AR8600 Bulletin Page

Failure of IC410 - over-voltage (early AR8600 MK1)

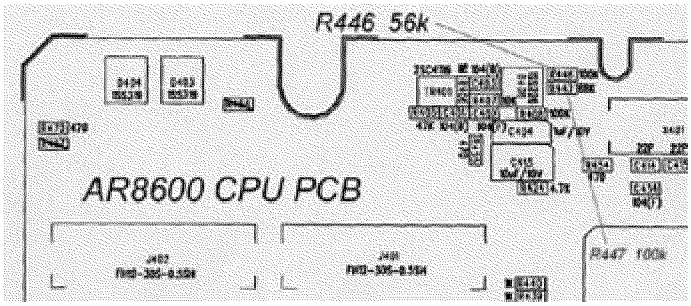
In both cases, the voltage regulator on the CPU PCB **IC410** (TK11245) had failed, which in

turn had damaged the EEPROM memory store **IC402** (AT29C512) on the same PCB. This resulted in spurious behaviour and the inability to change memory contents.

Both components had to be replaced, and it is suggested (by AOR Japan, the equipment manufacturer) that two additional diodes (1N4148 or 1SS1588 or 1SS266) are inserted in series with the un-switched 12V line between connector J403 and the regulator IC410… this is best achieved by a cut in the track between the unused +ve pad of C426 en-route IC410. It is likely that the 'system data' may need to be reinstated after component replacement, using a modified version of the EM8200 slot card (referred to as an AR8600 workshop tool).

Additional series diodes have been fitted to all new stock equipment in recent months to increase robustness of the power supply circuit (for occasions where an over-volt connection is encountered).

Change the following resistor values to restore normal operation:

- **R446 should now be 56k OHM** (was 100k OHM)
- **R447 should now be 100k OHM** (was 68k OHM)... you can use the resistor taken from R447

The change in value is due to the voltage drop presented by the series diode. The indicator should turn on when the battery voltage drops around 8.2V to 8.3 V. If you are not using the internal battery, ignore these component value changes. If you do not change the components, no damage will occur, the set will simply stop working when the BP8600 battery runs flat - without warning.
